Summary of ACD responses to Division deficiencies

Figure 18 Plots of water level responses and spring discharge rates during the pump-test at Y-61.

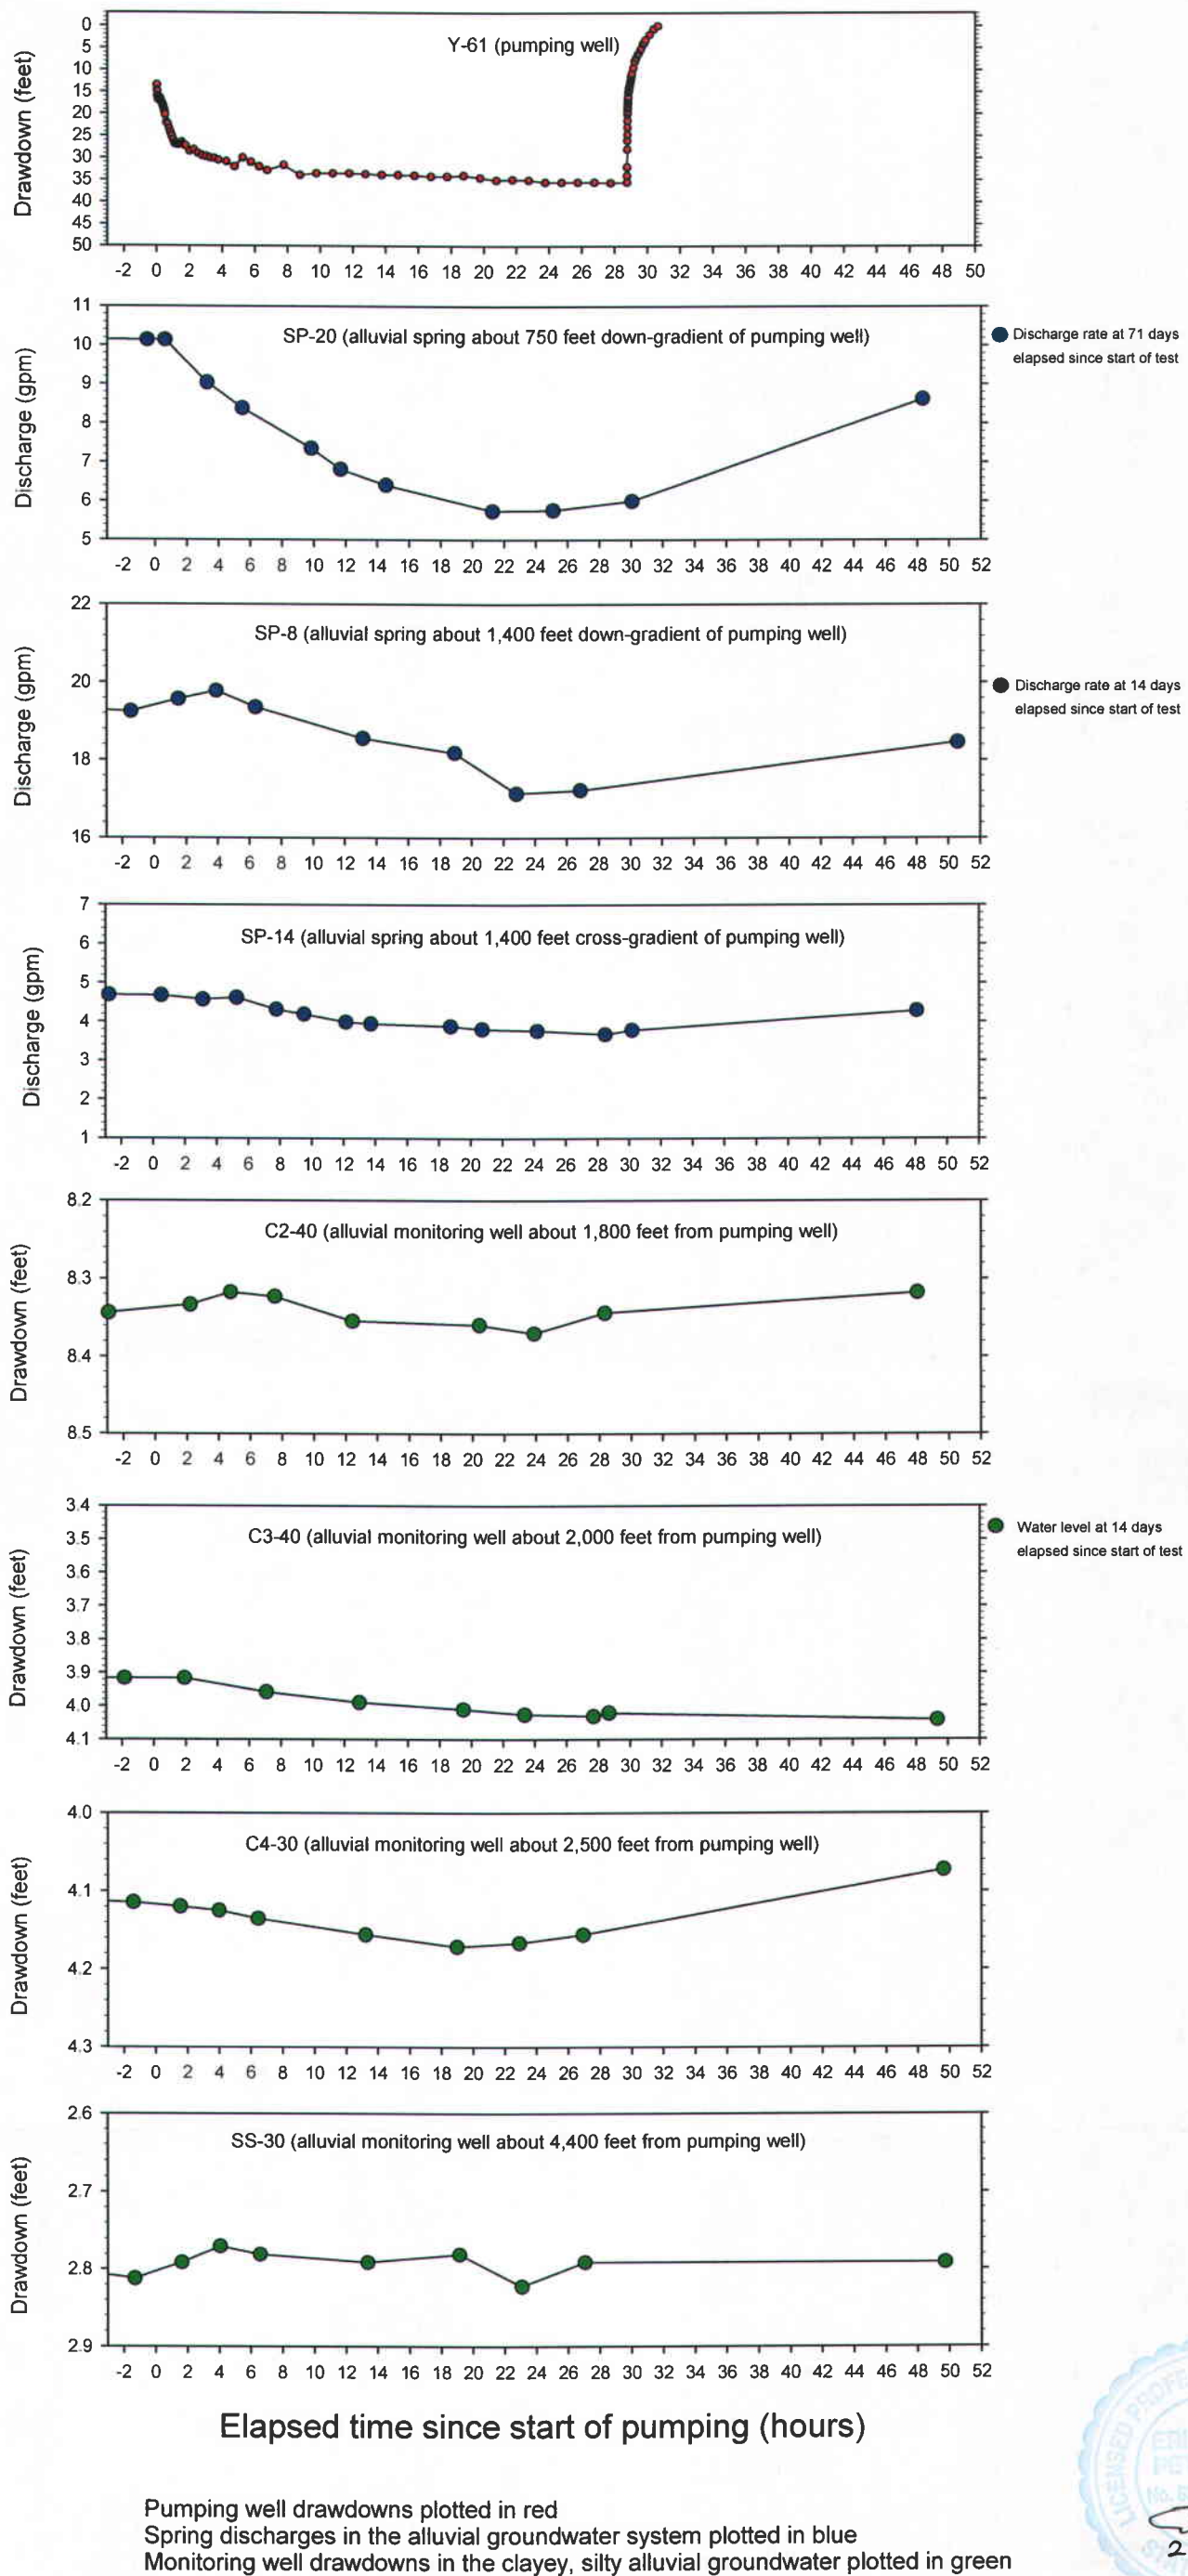
R645-301-722.100

Figure 18 of Appendix 7-1 (Petersen Hydrologic, LLC groundwater and surface-water report) is being replaced with a new Figure 18

Drawing 7-5 Map of specific conductance of alluvial groundwater in Sink Valley.

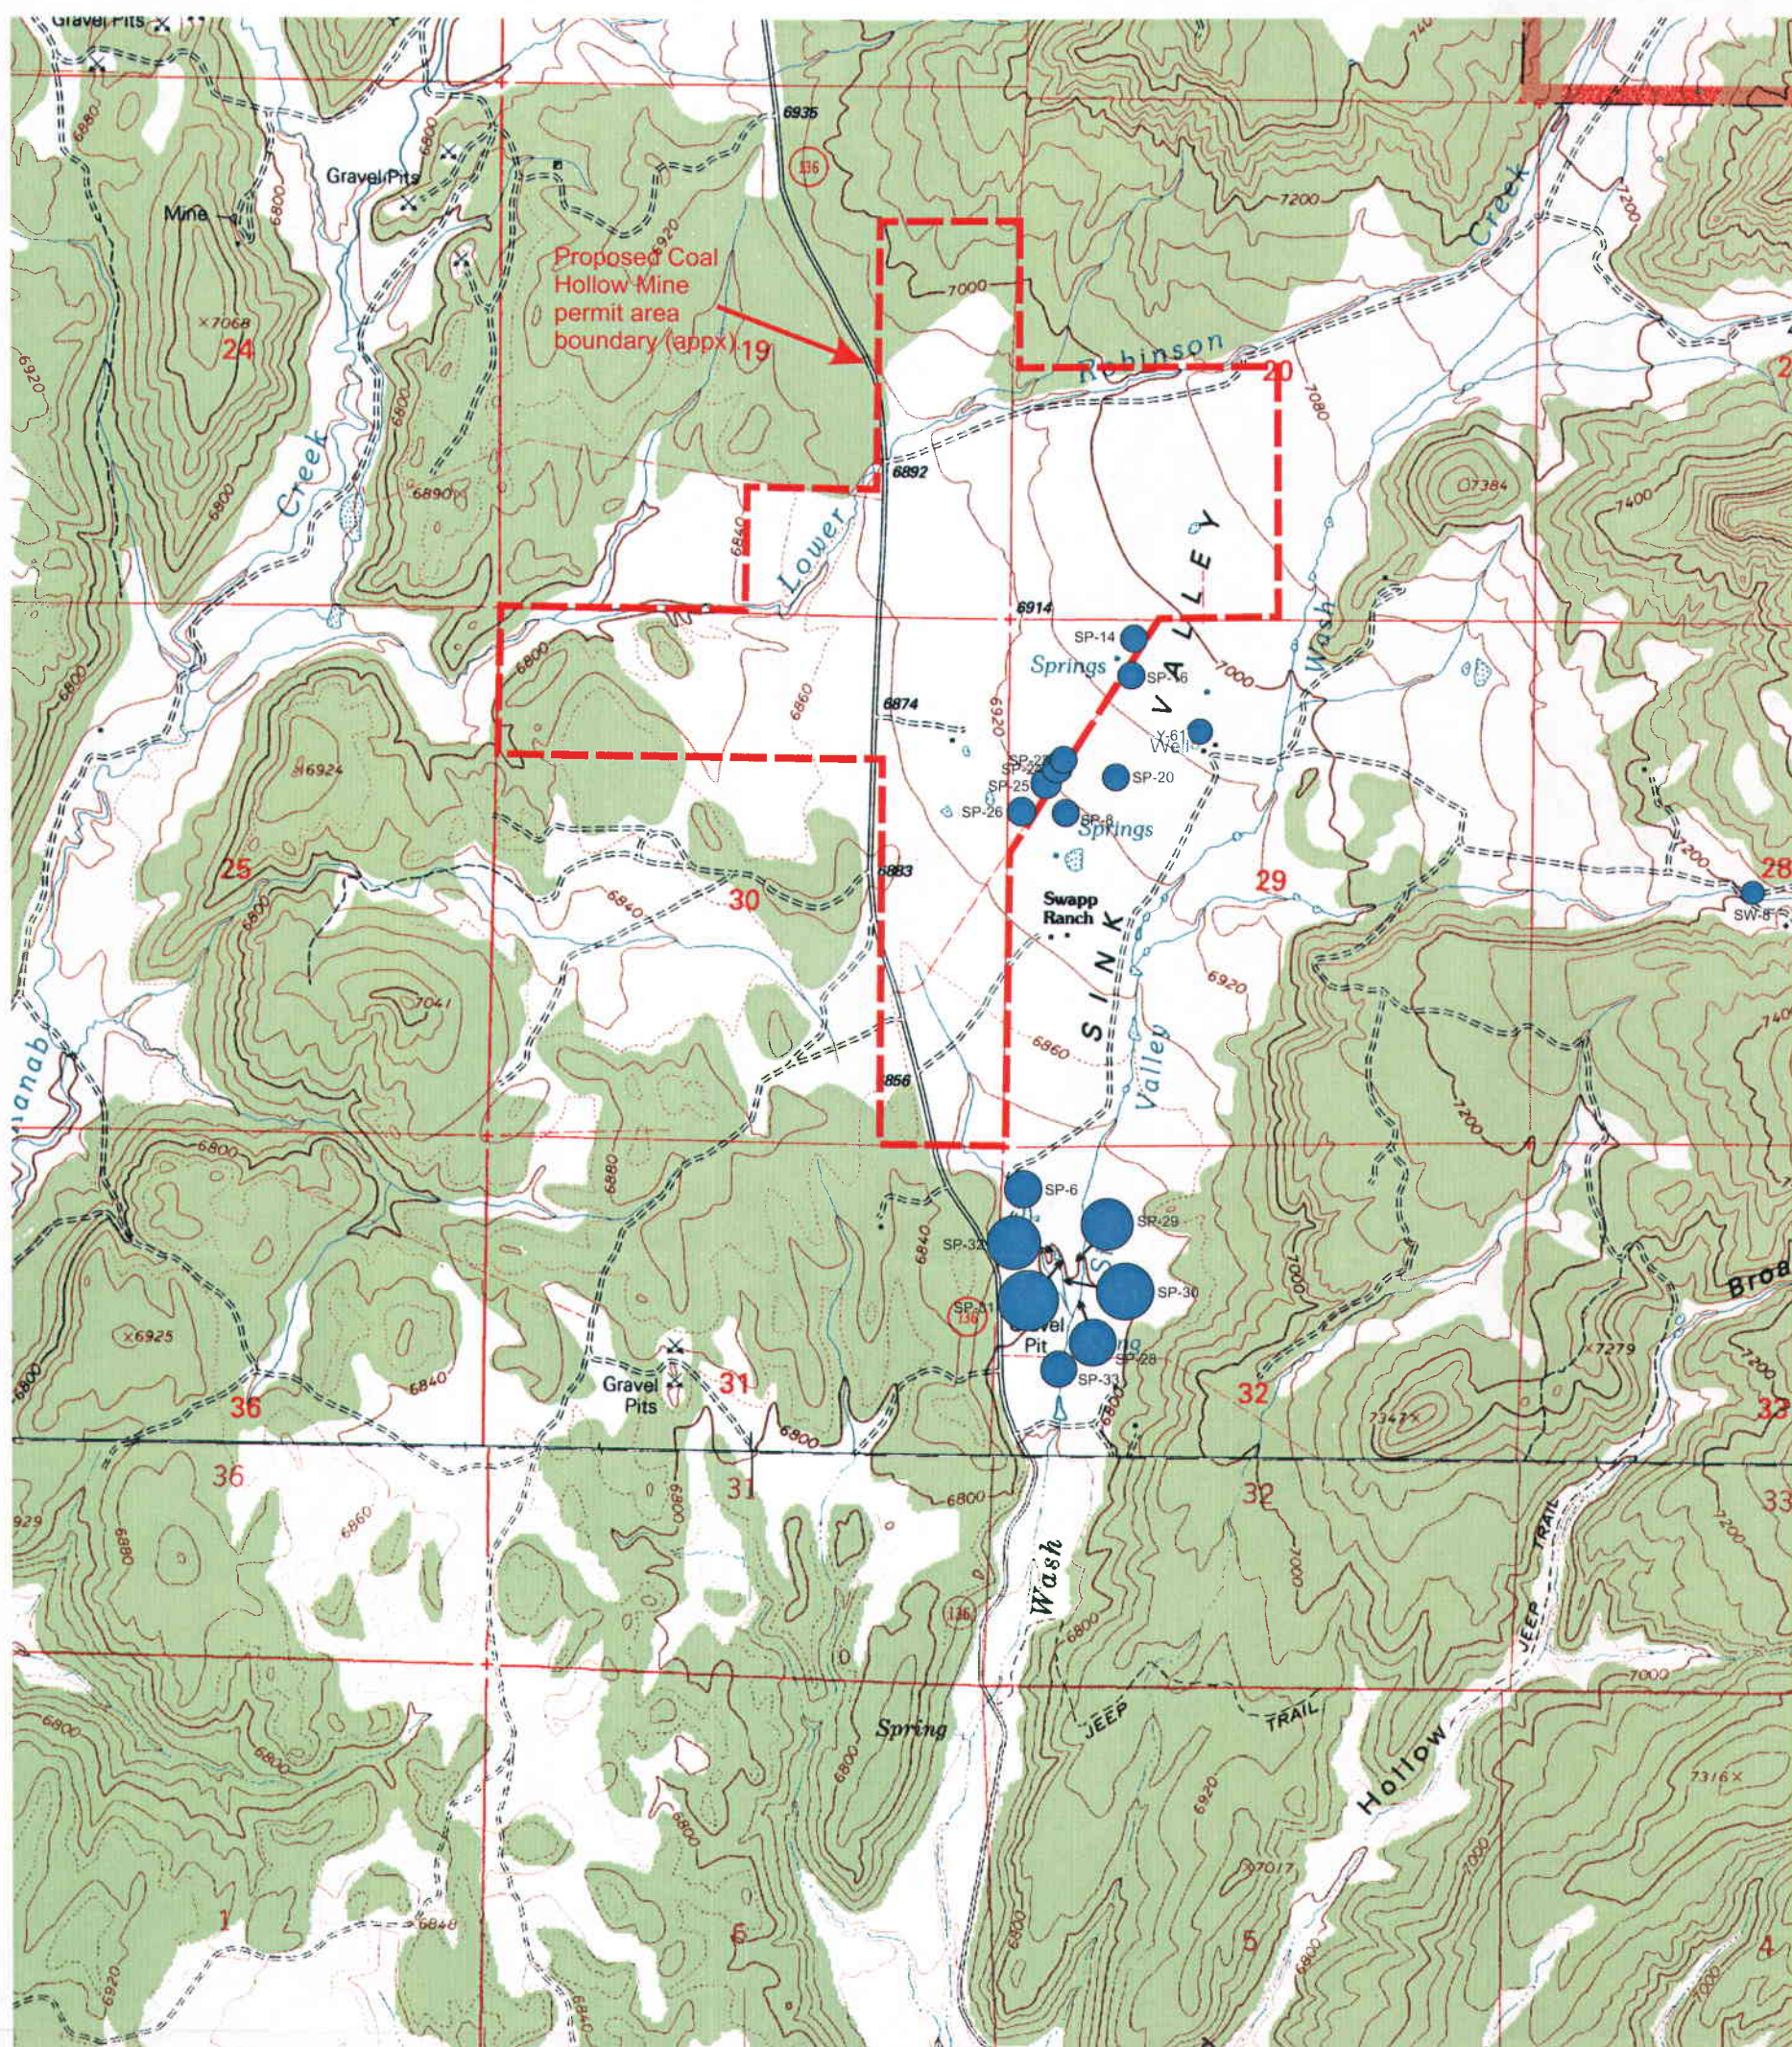
The applicant states that as ground water migrates through the shallow, fine-grained alluvial sediments in the proposed Coal Hollow Mine permit and adjacent area (most notably in Sink Valley), the quality of the water are naturally degraded: Appendix 7-1 is referenced for this information. The application needs a map or drawing that uses Stiff diagrams or some similar representation that will clearly show this degradation.

- Text describing the natural down-gradient degradation of alluvial groundwaters in Sink Valley was added to the section. Drawing 7-5, which shows this degradation using specific conductance values plots was added to the permit application and referenced.
